## ***Interactive comment on “Correction of upstream flow and hydraulic state with data assimilation in the context of flood forecasting” by S. Ricci et al.***

Author's response to Review 1 - Handling Editor: Dr. Jim Freer, jim.freer@bristol.ac.uk

**Fig. 4.** Initial Gaussian background error covariance function (black curve) and anisotropic background error covariance function (red curve) from KF, at observation point.

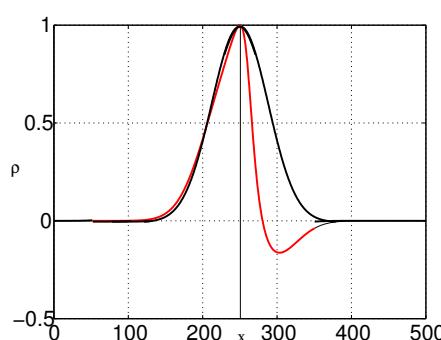
4. Section 3: Modeling of background error covariance B. This is potentially an important section since in the BLUE approach B is kept constant instead of evolving with time. However, the organization/presentation of this section is particularly poor, making it very difficult to follow. First of all, while it is important to do so, the purpose of the model simplification and that of applying KF and BLUE to the 1-D advection-diffusion model are never explicitly stated. Although one could get the idea after reading this sec-

tion and the next section a couple of times, the purpose of Section 3 should be explicitly stated upfront. Also, the description in 3.2 and 3.3 is pretty much fragmented with the results and interpretations from these experiments (including figs 5&6) presented in the appendix. The revised paper should focus on a better coordination between Sections 3.2 -3.3 and the appendix so that a complete story (short or in relevant detail) is provided in the body text.

The authors agree that this session is important and should be improved : the revised version of the manuscript aims at better presenting the purpose of the session and ease the reading of 3.2 and 3.3. In the revised version of the paper : - Session 2 introduces the idea that the KF algorithm can not be implemented on top of the MASCARET model (regarding the propagation of B) and that a model for B should be provided. - An introduction at beginning of Session 3 describes that the purpose of the session is to provide such a model for B. The major steps for the determination of such model are given : description of the simplified model, application of the full Kalman Filter to the simple model that leads to the parametrization of B and then the use of this B matrix with the Invariant Kalman Filter on the simplified model. - In 3.1 the advection-diffusion model is described. - Section 3.2 and 3.3 are organized to first described the background error covariance matrix with a KF (on the 1-D advection-diffusion eq.) leading to the parametrization of the covariance function at the observation point (previously 3.3), then to present the use of such parametrization with the BLUE (on the 1-D advection-diffusion eq.) and finally the assumption that this parametrization is also used on the Saint Venant model MASCARET. A new figure (Figure 4 attached) was added for Section 3.2.

**Fig. 5.** The Adour catchment with the measurement stations in red and the upstream stations in blue.

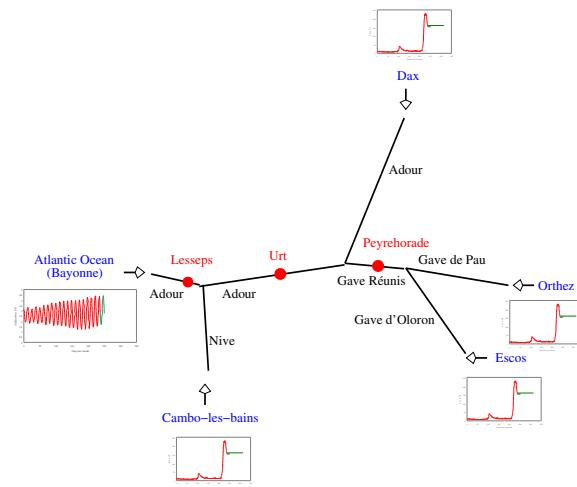
5. The description of the two catchments in Section 4.1 can be improved and consolidated. For example, currently some location names mentioned in the text cannot be found on the schematic diagrams (Fig. 7&8). Another example is the second paragraph

Figures 7 and 8 are modified accordingly to the locations mentioned in the text. Globally, the text was clarified, especially the Marne catchment description. See figures 5 and 6 attached for modifications.

**Fig. 12.** C1 (dashed-dotted), C2 (dashed) and C3 (solid) improvement en % between Assim run and Free run (red curves) and between Interp run and Free run (black curves). Average over seven flood events, at Peyrehorade (Adour).

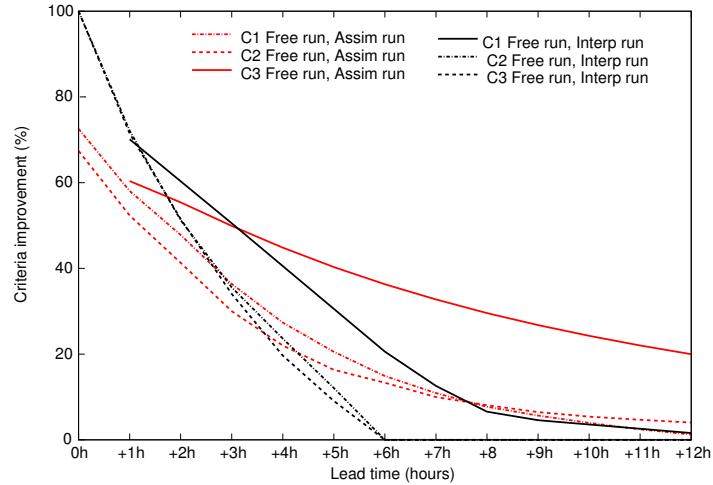
8.It is mentioned on page 9091 (Line 21-22) that similar performance was observed for shorter and longer range forecasts (as compared to six-hour forecasts). I am curious to see whether this is really true as normally one would expect to see forecast skill decreases with lead time (especially when the forecast is persistence based). As a recommendation, the authors could evaluate the skill as a function of time within both the analysis and forecast periods, i.e., evaluating the skill at every hour from the beginning of the assimilation window to the end of the forecast window (as oppose to only examining the performance at -24 hr and +6 hr). This would provide a more complete

9.As a suggestion, the authors could compare the DA results to another baseline scenario where the most recent water level observation is used to directly initialize the

model to make a forecast, in addition to a free run starting from several days earlier in the past, not using recent observations that are already available. One would argue that such a baseline is expected to perform better than the free run defined in the paper, making it more difficult to demonstrate the value of data assimilation.

As suggested for page 9091, statistics over the events were computed to illustrate how the forecast skill decreases with lead time. The statistics were computed for the Adour catchment (over 7 events instead of 5) and the Marne catchment (over 4 events) in re-analysis mode (24h before the lead time) and in forecast mode (hourly, up to a 12h forecast). The improvement between the free run and the assimilation run, for the 3 criteria (C1, C2, C3) is plotted in % as a function of the lead time (see figure 12) for the Peyrehorade station on the Adour catchment.

As suggested by reviewer 1, the DA results were compared to another baseline scenario presented in 4.1.2. Initializing the model to the observation state at the last observed time (as suggested) was not possible since this I.C is not coherent with the model equations (spatial discontinuity, inconsistency between water level and discharge since only water level is observed). The new baseline scenario consists in a post treatment of the free run integration for the forecast period. The difference between observation and free run at observation point is computed. The free run simulation is corrected over a 6h forecast period, the correction at lead time is equal to the increment, the correction at +6h is zero, in between, the results are interpolated linearly. This scenario has a 100% improvement skill at lead time and 0% at +6h.

The improvement for the 3 criteria between free run and the interpolation scenario are also presented on figure 12.
